BPRD Comments re: 70 Leo M. Birmingham Highway

Re: 70 Leo M. Birmingham Parkway Project, PNF

Comments on 70 Leo Birmingham Parkway Development
Tracy Wu
Portsmouth St. Traffic Task Force Committee

70 Leo M Birmingham Parkway Comment Letter

<Property Line Sketch with Abutter.pdf>

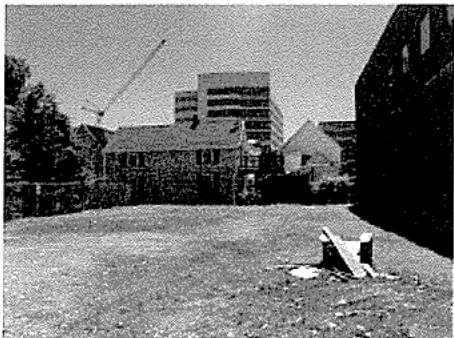
Please send me a detailed description of the location and distance from my property.

As detailed during our many preliminary and recent community presentations (which you have attended), the attached sketch shows that my client's proposed building has been specially designed to respect your property by **complying with the required side and rear yard set-back requirements of the Zoning Code (for this section of the new building along your property line)**. In this regard, a 5 foot set-back is required from the shared property line at the side (Side Set-Back) and a 20 foot set-back is required from our rear lot line at the back (Rear Set-Back).

In further deference and respect to you and your property, the attached sketch also shows the following measures meant to address your input and concerns expressed to-date, as we understand them:

- 1. NO WINDOW OPENINGS on the side of our new building facing directly at your house or deck.** Rather, in response, we specifically eliminated any window opens from this area, and our first window opening at this section

along your property is beyond the area facing the end of your garage.

2. Due to the new building's compliance with the 20 foot rear yard set-back, **all views from the side section of your house remain essentially unobstructed, to look over open space (not blocked by new building structure).** This should also be clear from the notations on the attached sketch, where your final side window is located.

3. I also note that, while a portion of my client's proposed new building runs along the rear side of your existing side deck, **the back of the new building actually steps down to ONLY TWO (2) STORIES, before stepping up to its taller sections. Coupled with the fact that your deck is also elevated (see attached photo of your site looking over the rear of my client's property), the result of this additional responsive design measure is to further respect and respond to your property conditions, with a two-story rear building section that is actually LESS THAN the Zoning Code's 35 foot height requirement for this particular section of the new building.**
